Title			GLUCOMETER
Size	Document Number	Rev	2.1
C	SCH- 20110117_ARGOS_GLUCOMETER		
Date:	NOVEMBER 10 2010	Sheet	1 of 1

Analog Front End connector for Communication or LCD Board 2x10 PTH R/A .100"

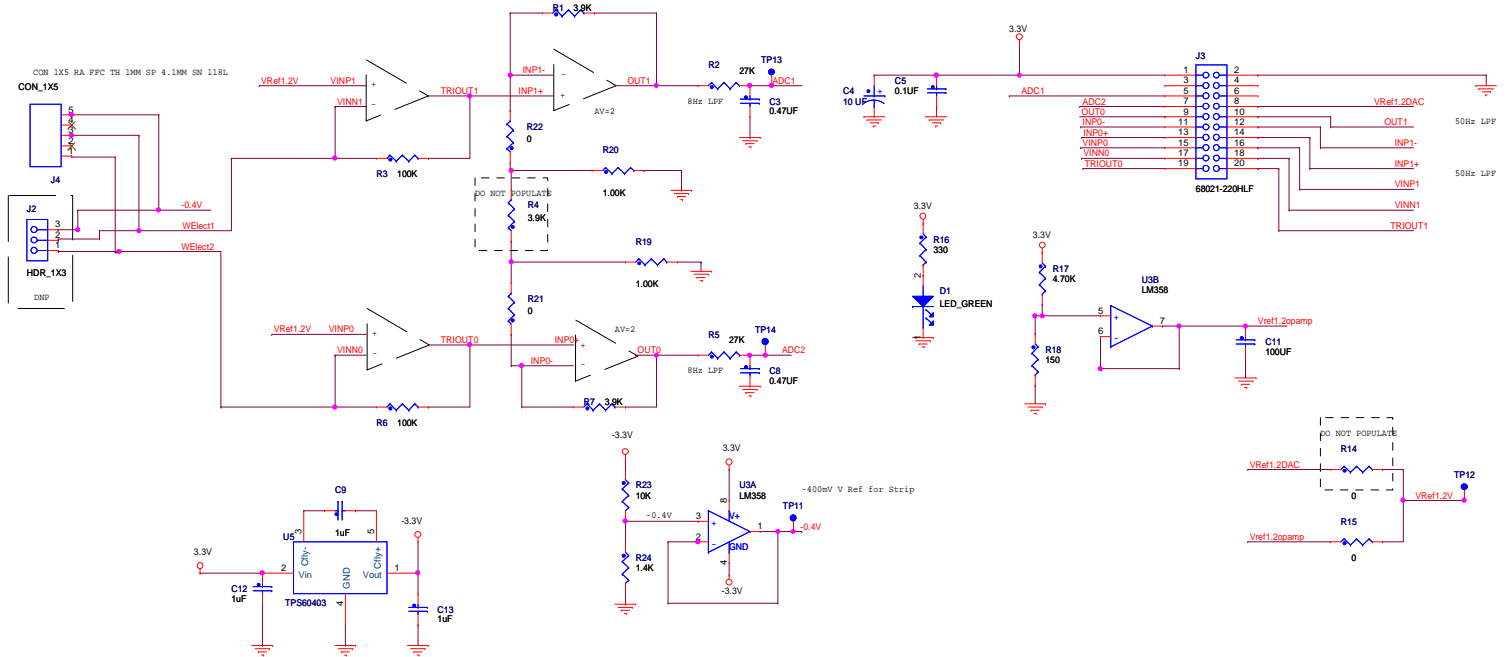
verificar tierras

For use this AFE with Tower do not populate U1 and U2.

At Layout, modify the 0603 resistor footprint for a 0603 resistor and 2 holes for axial resistor with a .100" pitch.  
Apply this changes for all resistors and all filter capacitors.
